ANPR PLAN

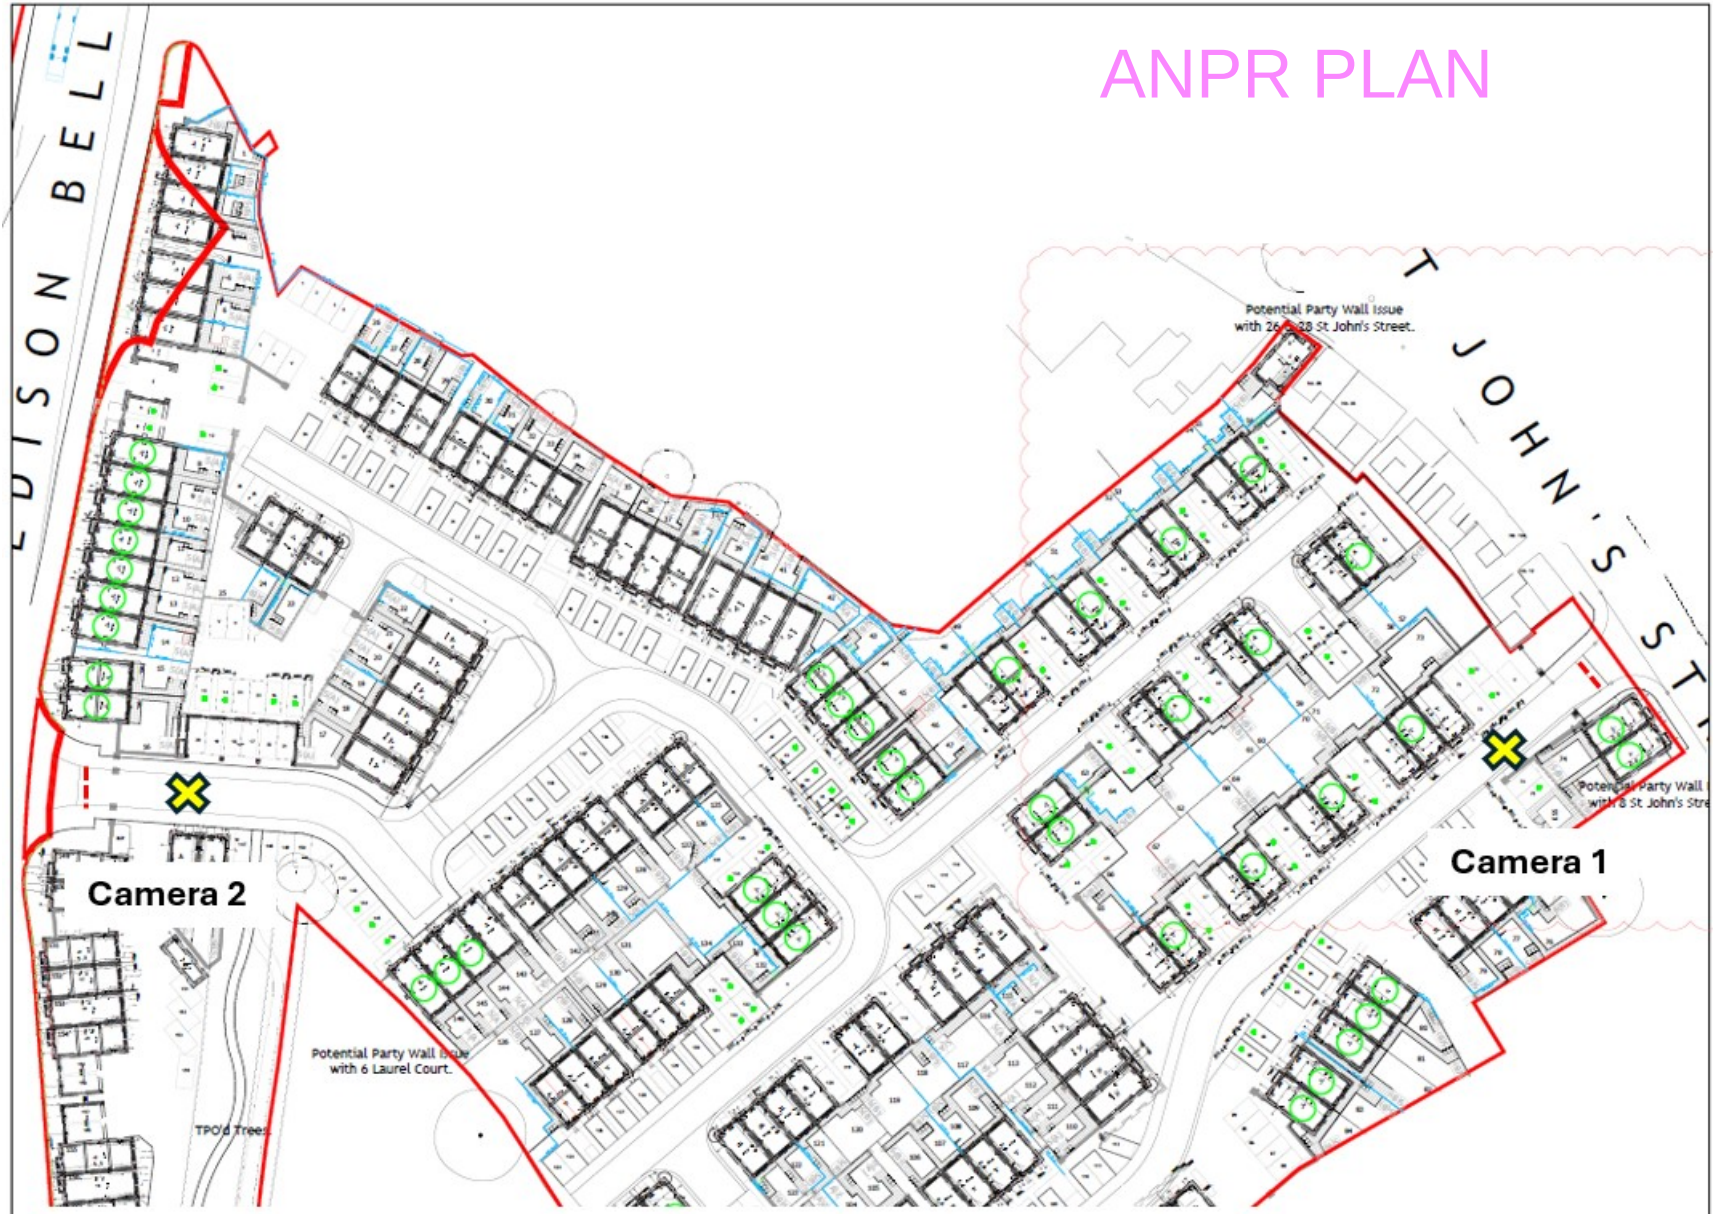
Further to our recent meeting – please find a revised plan showing proposed ANPR camera points – whilst these show the cameras in the middle of the road, they are to be installed on lamppost columns on either side of the roadway approx. 10m back from the RED *read* line shown.

The location of camera 1 has be changed to include the whole roadway, including vehicles entering into Godwin House (GH) these will be excluded from enforcement with an exemption list managed internally by GH.

Previously suggested locations for camera 1 resulted in the majority of the roadway being unmonitored and the camera only covering a small dead-end section.
